APPLICATION NO.	FILING DATE	FIRST NAMED INVENTOR	ATTORNEY DOCKET NO.	CONFIRMATION NO.
10/824,447	04/14/2004	Steve Karaga	051110-1010	6607

Office Action Summary

DETAILED ACTION

Jones US-355,825

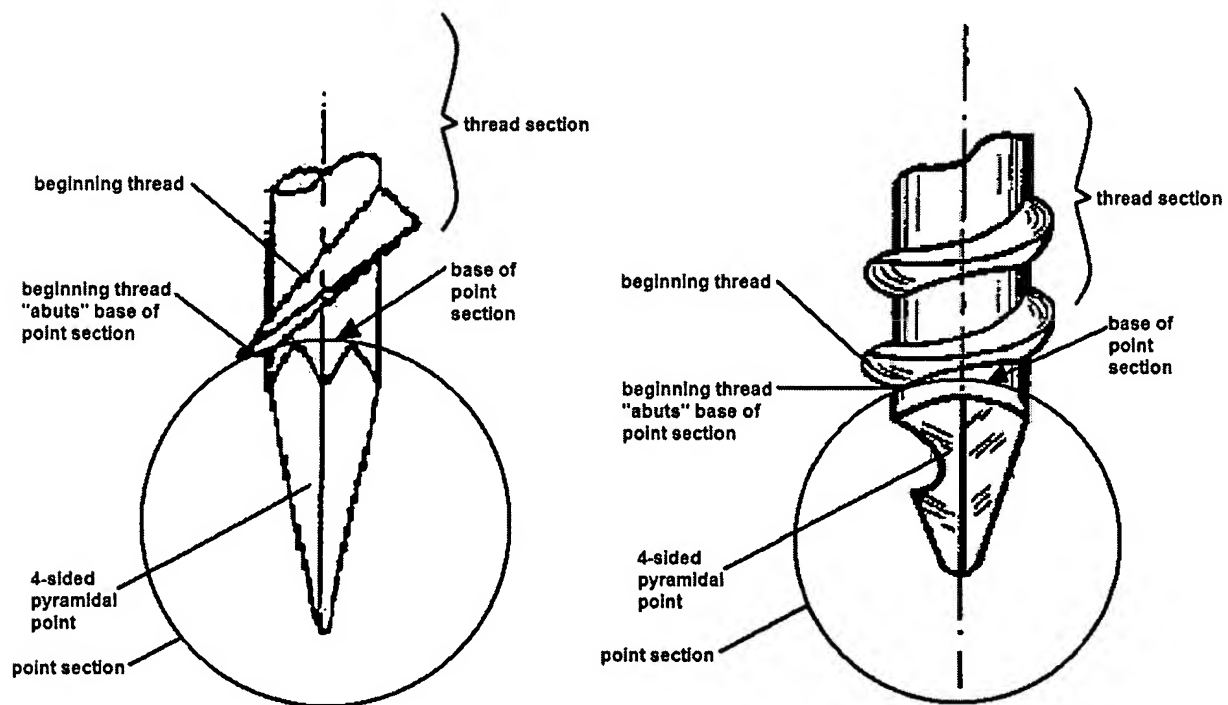
Jones US-355,825 teaches a cone-shaped or diamond-shaped point (i, pg 1 lns 73-75) in combination with a thread section (e), tapered head (g), unthread section (f), and engagable unscrew means (h). Jones uses a lesser pitch that would be within a non-obvious reach of 60-63°; however, still intends the screw to be driven via hammer blow, and released by unscrewing (pg 1 lns 85-89).

Present invention (left) Rockefeller US-4,572,720 (right)

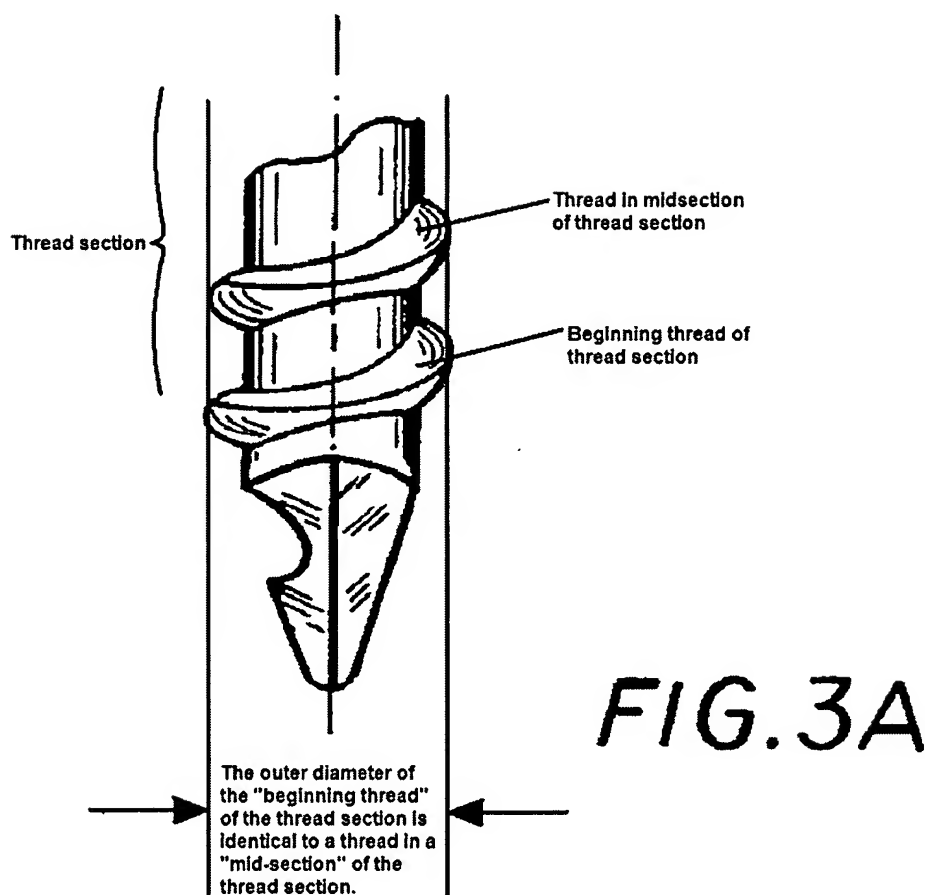
Applicant has amended the foregoing claim(s) such that (as it is understood), the point section has a point and a base. Rockefeller still suggests (as does Applicant) "threads of a thread section abutting a base of the point section". This is clearly demonstrated in the figure below.

Regarding Applicant's remarks concerning the added limitation "the beginning of the thread having the same outer diameter as the thread in the mid-section of the thread section" is not shown by Rockenfeller '720, attention should be drawn to Figure 3A of Rockenfeller '720. Rockenfeller clearly shows a "beginning thread" most adjacent the point section having the same outer diameter as the rest of the threads of the thread section. It is to be noted that Rockenfeller dimension "d1" refers to the "root diameter" of the threads, and "d2" indicates the "outer diameter" of the threads. Nowhere does Rockenfeller suggest a *different* outer diameter for the leading (i.e., "beginning") thread.
